TENDER ADDENDUM AND CLARIFICATION No. 20 (TAC 20)**RE: Procurement of Plant, Design, Supply and Installation of the 220kV Mariakani - Dongo Kundu Transmission Line and Associated Substations (KETRACO/PT/045/2023)**

A. Clarification No.20

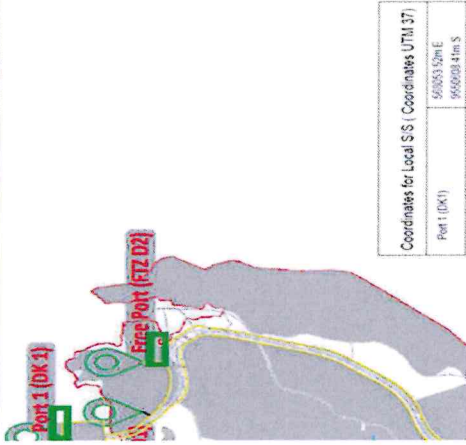
5.	22-Section-VI-1E-Drawings-Transmission Line & 07-Section VI-1B_04_ Insulators and Fittings-20230704 Clause 4.2.6 a			As per 07 Section VI Insulators & Fittings clause 4.2.6.a, The Counterweights shall be exclusively used for Jumper Suspension Insulator Sets however, as per 05-MSEZ-2022-TL-C-004_Standard Type of Towers_1, it is mentioned that, The Counterweights shall be used for Suspension Insulator Sets also. Kindly clarify whether we need to use counterweights for both Suspension & Jumper Suspension Insulators also? 2. As per Clause 4.2.6, "Double insulator strings shall be designed to ensure that following the breakage of one insulator string, the set shall remain intact and withstand the resulting static and dynamic loadings imposed" Kindly clarify whether the Insulator String for Suspension Insulators shall be with Single Point or Two Points attachment on Tower Cross arm.	1. Counterweights should be applicable both for suspension (Single and Double String) insulator string sets as well as Jumper 'Pilot' Insulator String sets (Which is suspension by nature) as the case maybe hence the need to have these insulator string sets designed with a mechanism / facility to facilitate attachment of the counterweights if design necessitates them. Its anticipated weight (as specified) should contribute to the tower loadings during design. 2. Single point is applied as shown in the drawing no. MSEZ-2022-TL/E-005
